Ref: EP-SL-002	ID: 0840
	V20-Replacement of M4 screws	Revision: 2.00
		Date: 27-Mar-2023
Page 1 of 1	SERVICE LETTER	Visa: SD

Affected Propellers: "Durandal V20" series produced before 2022.

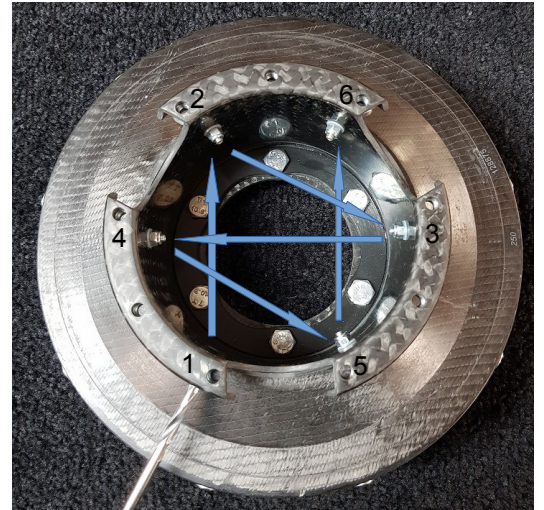
Reason: Corrosion on M4 screws for the fixation of the spinner back plate on the spacer.

Action: Replace the M4 screws by M5 screws without washers.

- Check the alignment of the back plate on the spacer.
- Tighten the M4 screws
- Remove one M4 screw, drill the hole to 5.00 mm, tighten the M5 screw to 5 N.m
- Repeat this operation for the other holes, in "star" order,

for example on a 3 blades Durandal :

M4 screw

M5 screw
